OICA contribution to HV safety

Part 1: OICA replies to NHTSA's question

Part 2: OICA's proposal for low energy content in Y-capacitances for in-use (i.e. active driving mode) and post-crash situations

Part 1: OICA replies to NHTSA's questions for HV Safety

DC AND AC TIME/CURRENT ZONE GRAPH COMPARISON, IEC 60479-1:2018

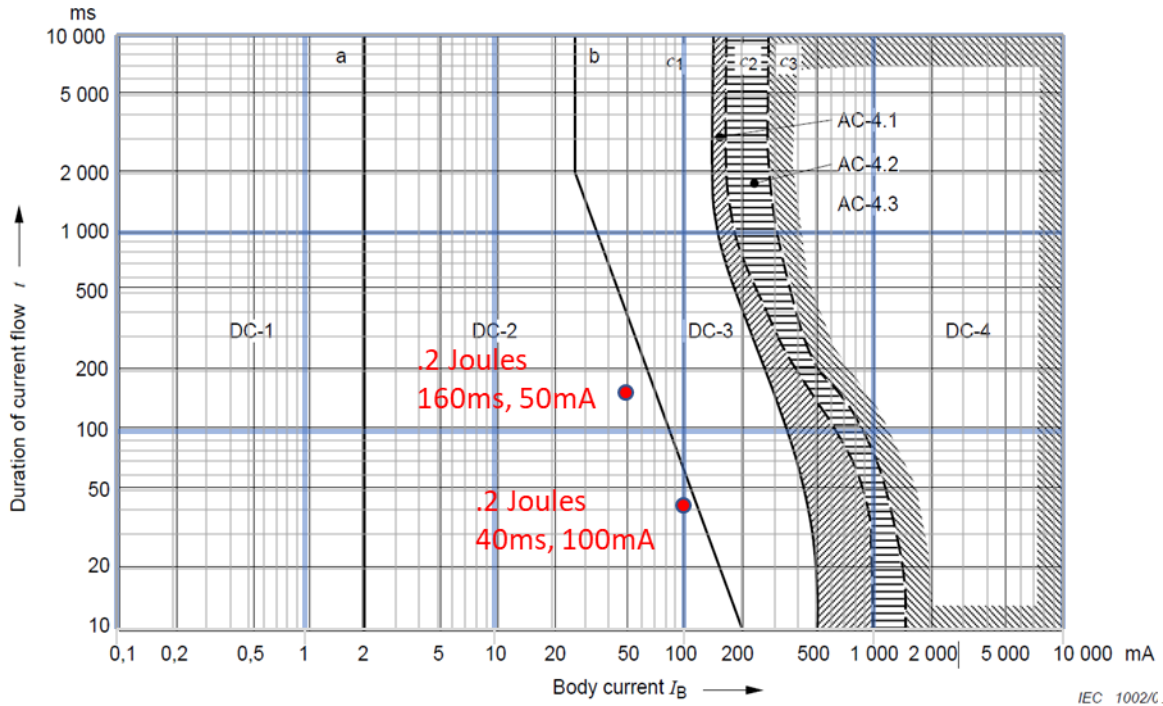
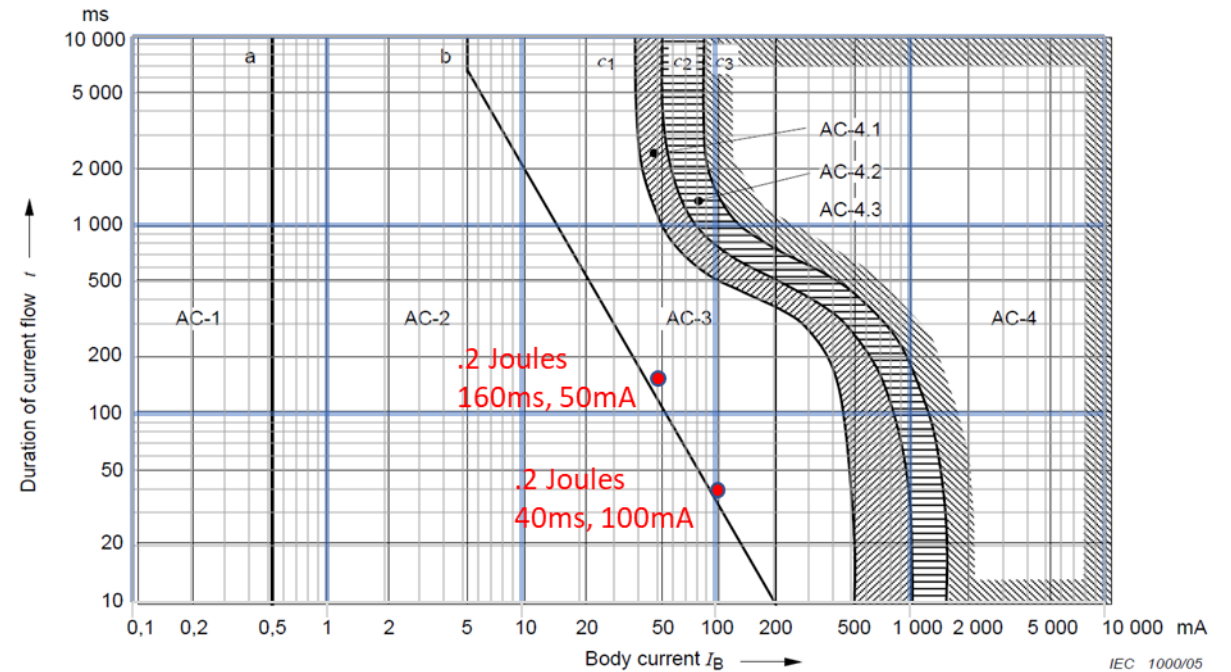
0.2 J low energy option for current duration greater than 10 msec: The 60479-2 Section 11.4.2 suggests using IEC 60479-1 Figure 20. I questioned the validity of using Figure 20 instead of Figure 22 on IEC 60479-1. I believe it was OICA who reanalyzed and said that the answers are the same whether Figure 20 or 22 are used – the 0.2 J energy values fall in AC-2 and DC-2. We did this analysis and we get different results if Figure 20 is used instead of Figure 22. We would like discussion/clarification on this matter. Our thought is that since the capacitor discharge is unidirectional, Figure 22 (DC current) should be used.

Sample calculated energy plots shows the .2 joule limit crosses into the zone 3 boundary on the AC signal graph.

- Coordinates plotted are:

1. (50mA, 160ms) -> .2 Joules
2. (100mA, 40ms) -> .2 Joules

- Based on this data, there is a difference in safety assessment using Figure 20 and Figure 22 of IEC 60479-1.

REPLY: The statement is correct, Figure 22 of IEC 60479-1:2018 from should be used.

Figure 14 - Combined Y capacitance limit

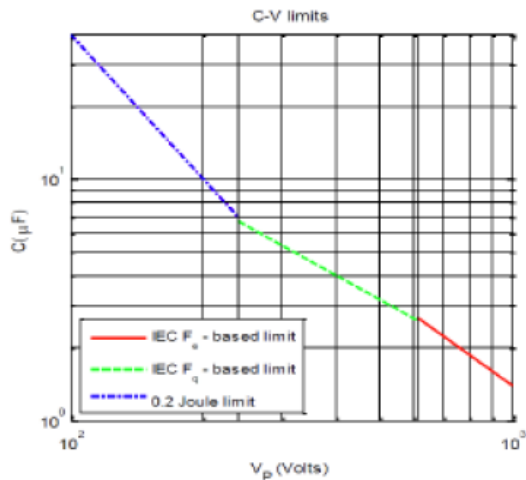
NHTSA Comments on the proposed energy limit driving mode

Correct derivation of maximum capacitance

Mitigation from current energy requirement of 0.2J

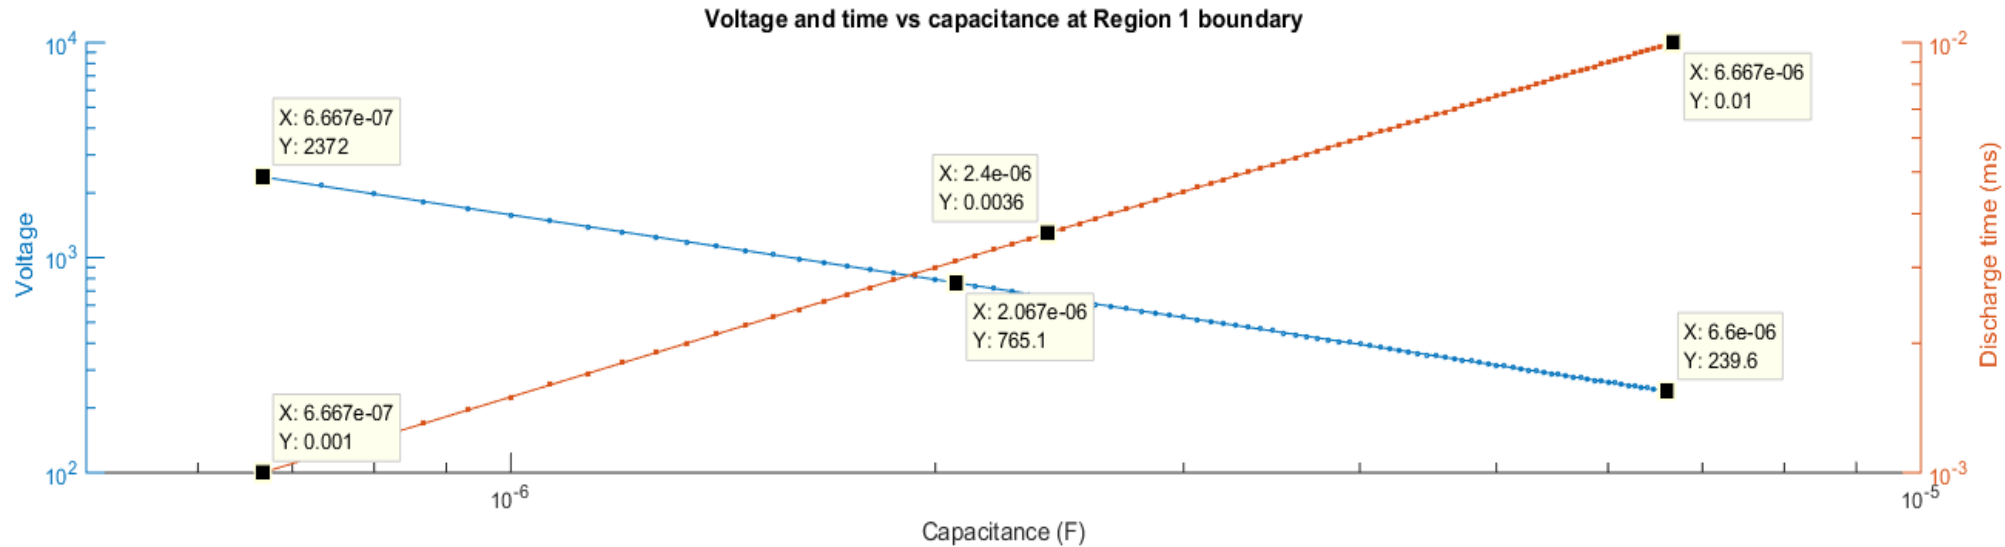
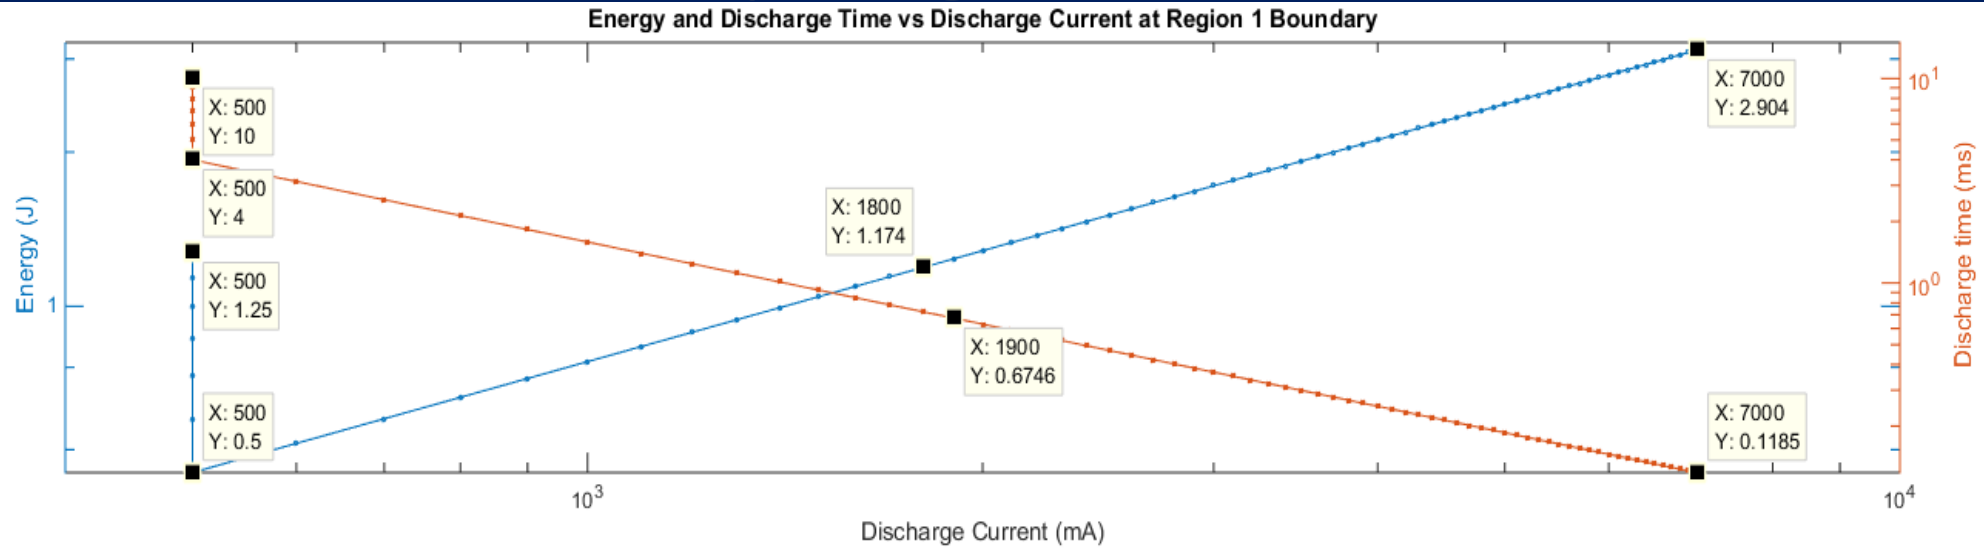
- Is the industry proposing that the 0.2J energy limit should only apply to bus voltages less than 240V in active driving mode?

- 240V is the maximum voltage assuming 10ms discharge time or 6.67µF capacitance. This voltage limit can be increased with lower capacitor values without having to shift the energy threshold.

- Refer to Voltage plot on slide 5. These values were derived using SAEJ1772 equations.

OICA: YES.

NHTSA Energy and Voltage plots based on SAEJ1722 along the C1 boundary in Fig 20 of IEC 60479-2

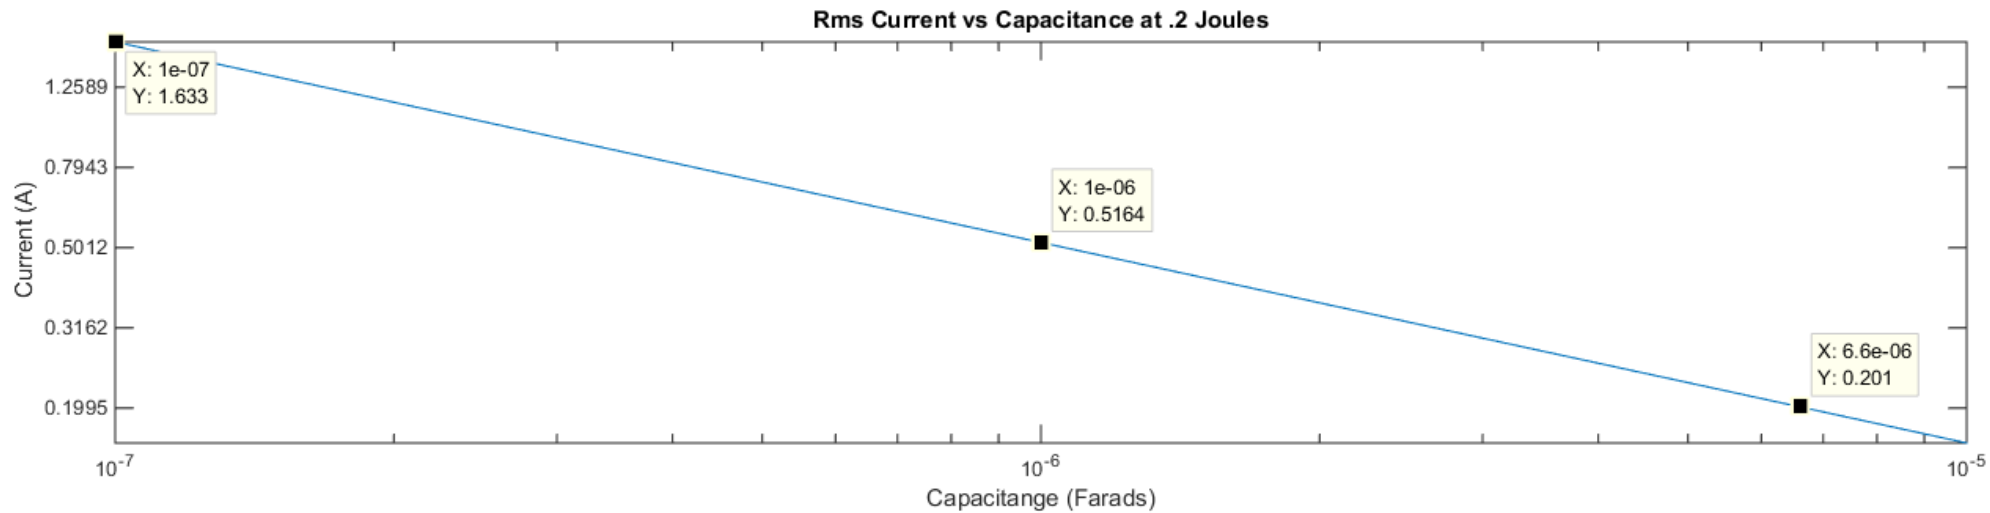
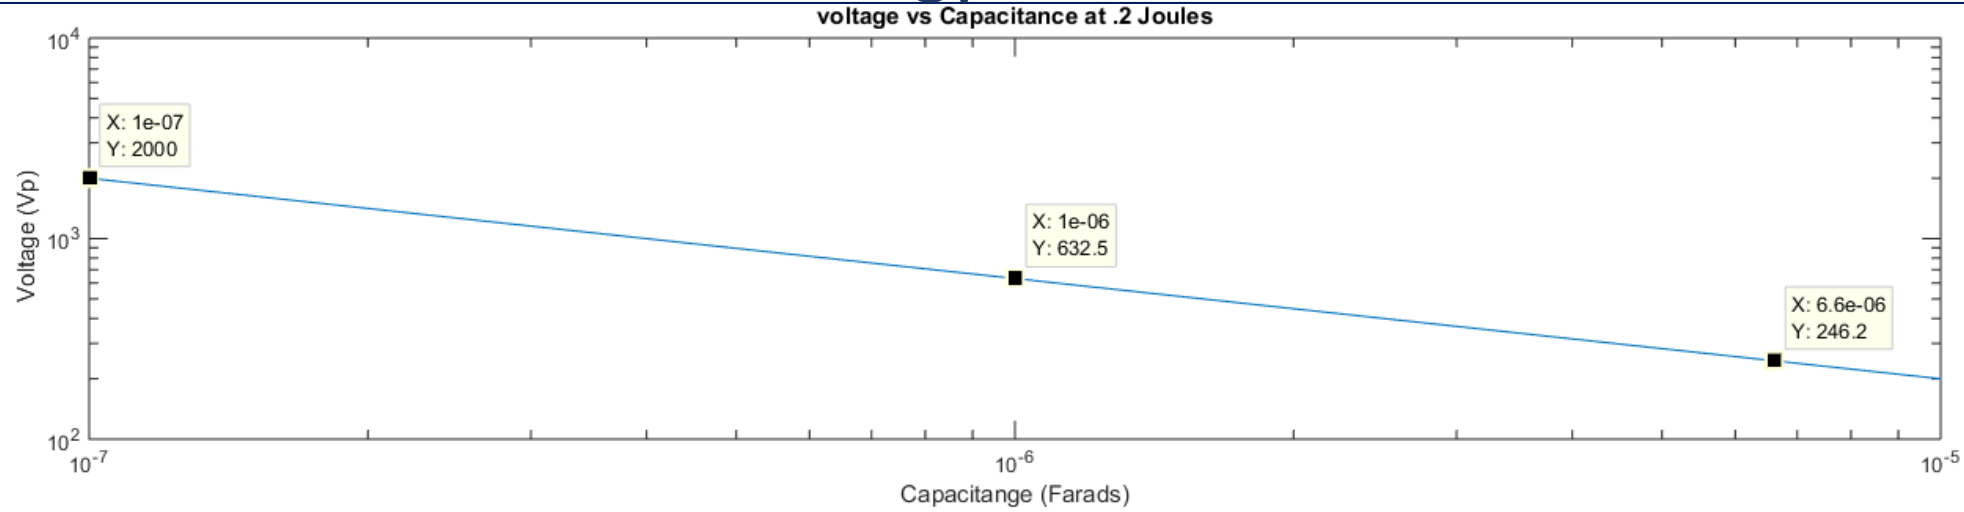
- Where do .5J and .7J lie on the IEC 60470-2 Figure 20 boundary map, compared to .2J?

See Figure “22 – Threshold of perception and threshold of pain for the current resulting from the discharge of a capacitor (dry hands, large contact area)” IEC TS 60479-2, Edition 4.0 2017-10 (all of those values are not shown there)

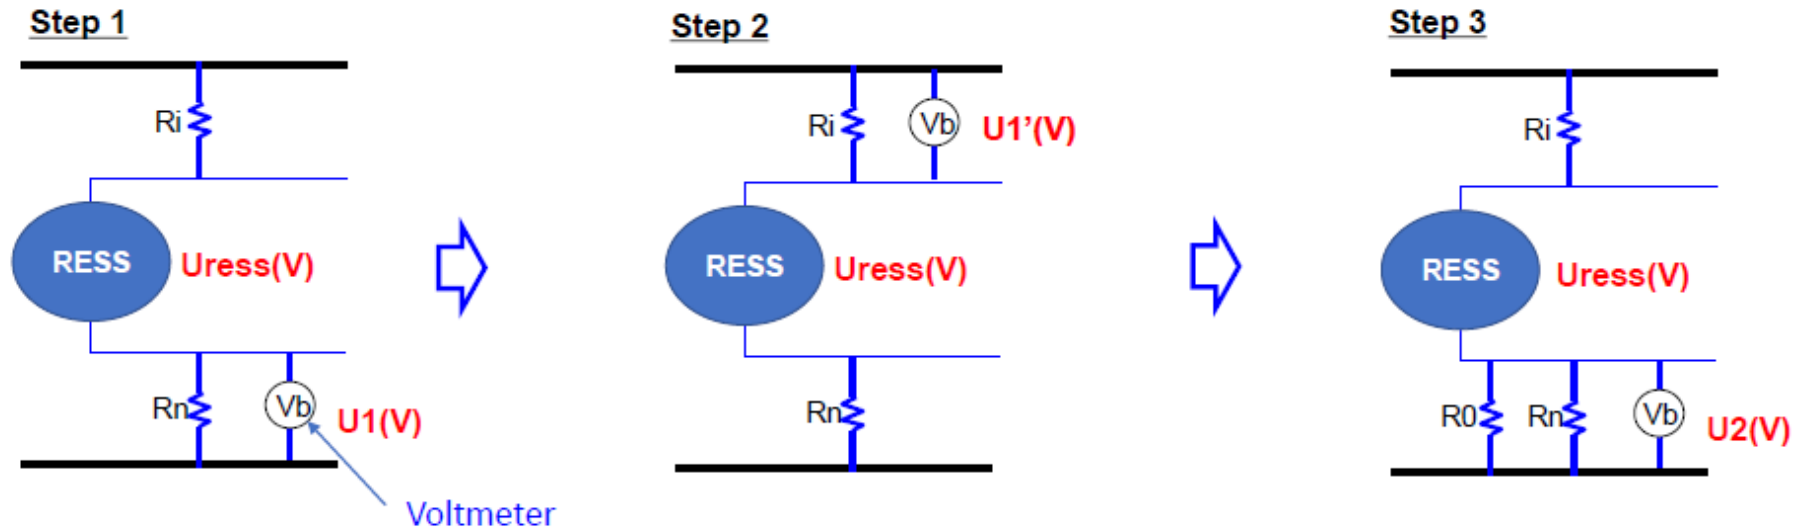
- We would like to open a discussion regarding the use of high impedance voltmeters for this test. Possibly >100Mohm.
- The use of these high impedance meters would make the measurements more reliable by making '1/ra' more negligible.

NHTSA: “In response to the Chinese proposal on an alternative method of calculating electrical isolation by using two different voltmeter readings, JARI showed that the resistance of the two voltmeters need not be the same but that the voltmeter resistance influences the computed electrical isolation value. We would like to discuss the need for including such a method in the GTR as JARI suggested. We are concerned that if the voltmeter resistance is not high enough, it could result in inaccurate values of electrical isolation and reduce the reproducibility of the assessment.”

Result: OICA supports NHTSA's concerns.

GTR20 measurement procedures

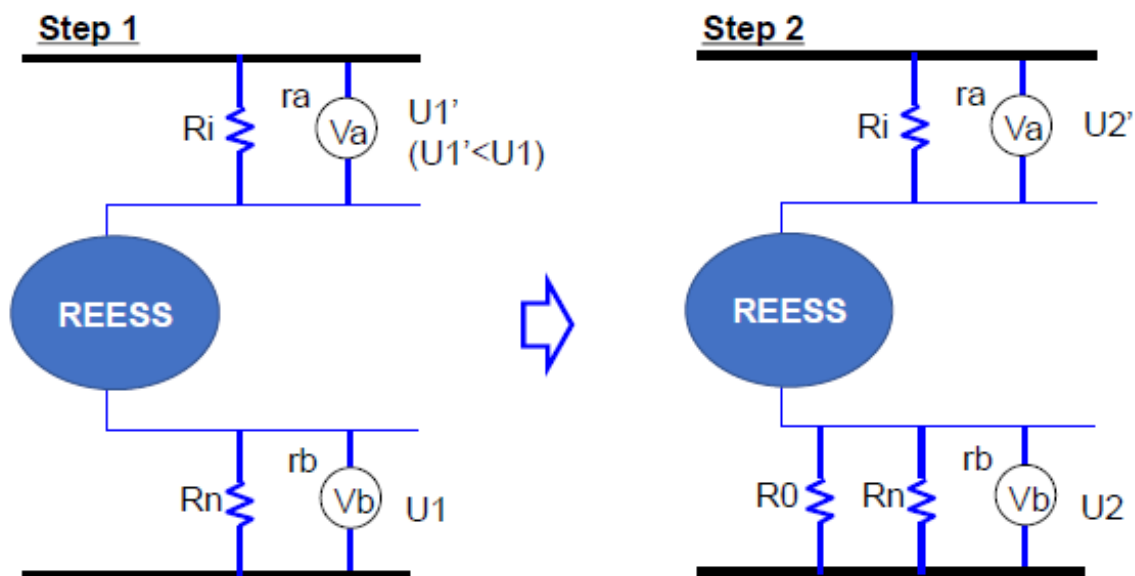
- The place of a voltmeter needs to be changed several times for the isolation resistance measurement.
- $R_n > R_i \gg \text{Internal resistance of the voltmeter}$ → Measured voltage values (U_1 and U_2) are almost zero.
→ In some cases, the values may be too huge for a proper calculation.

Figure 20 – Threshold of ventricular fibrillation

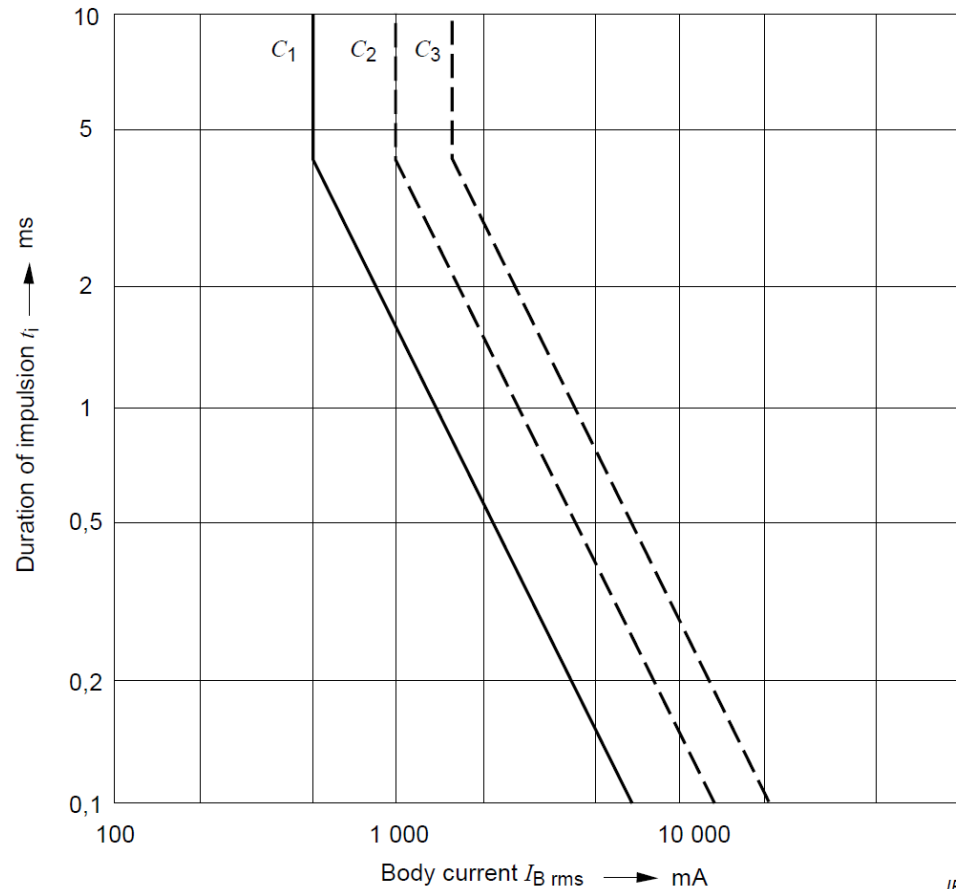
As the corresponding diagram shows, a pure energy criterion can rule out technical solutions that don't lead to danger for human beings, but cannot rule out certain situations that can be hazardous for human beings.
